15  
**DESIGN EXCEPTION #DE14-02**

To: Mark Relph, Director of Public Works & Utilities  
Thru: Tim Moore, Public Works Manager  
Copy to: Dave Donohue, Development Engineer  
From: Mike McDill, City Engineer  
Date: June 11, 2002  
RE: Exception from Maximum Block Length for Eagle Subdivision

# EAGLE SUBDIVISION

Figure 2

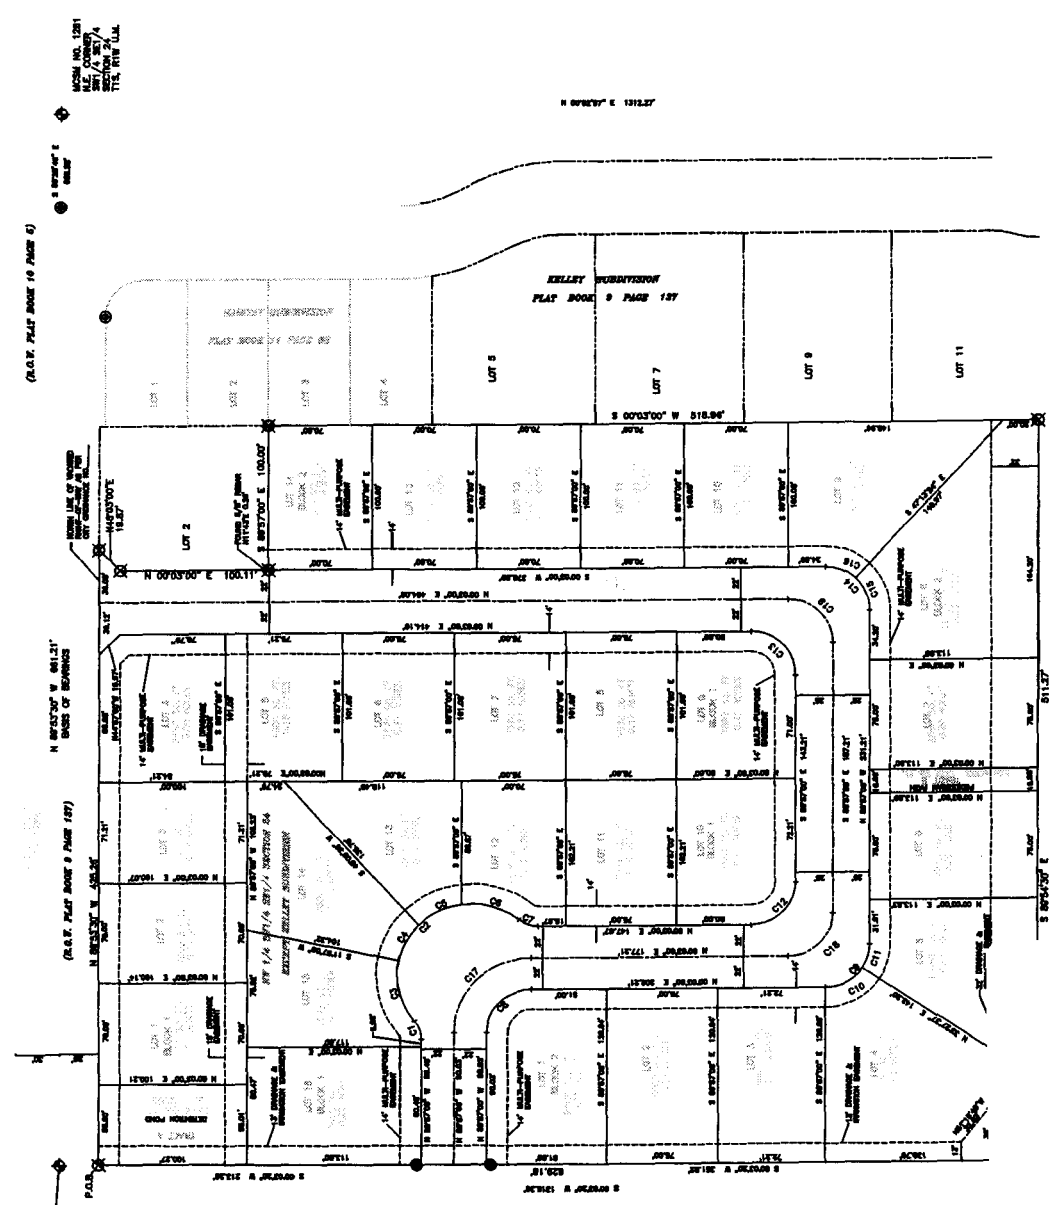
Applicant is planning to develop approximately 7.5 acres into 30 residential lots. The attached plat was approved through the preliminary plat process. It was the result of considerable revision to comply with the access spacing standards along Cheyenne Drive. Only later in the review process was it discovered that the approved block length might be longer than the maximum. There was considerable discussion and difference of opinion between staff as to the correct definition of "block length." This Design Exception will serve to resolve this issue for this subdivision. Forthcoming direction from the Traffic Engineer will eliminate any confusion on this issue in the future.

The applicant requests exception from Section 5.1.1, *Block and Lot Dimensions*.

Because the long block will have accesses from both ends, compared to two cul-de-sacs, safe traffic and pedestrian flow should not be compromised.

Several other layouts were considered during the Preliminary Plat Process. None of them would have intentionally met this standard. There probably was a way to layout this development so as to meet all of the TEDS criteria, but it was not finally selected by the developer and staff to proceed to the final plat phase.

The city has many subdivisions with block lengths over 1200 feet. With a clear common understanding of the definition of "Block Length," the Community Development, Development Engineering and Traffic Engineering staff will proceed to uniformly enforce this element in the future.

I recommend approval of the necessary Design Exceptions to Section 5.1.1 to allow the proposed over length block.

I support this exception and would find that it meets the review requirements. I also support clarification through a TEDS manual update.

In summary, the length of block does not meet the TEDS requirements. However, it still has two access points. There has been some disagreement with the specifics of this requirement and will be clarified in a future update of TEDS. I personally want to approve this request and clarify the TEDS requirement. I would appreciate your comments. Let me know if prefer a hard copy and I will get one to you.

I also support the exception and need for clarification in TEDS.
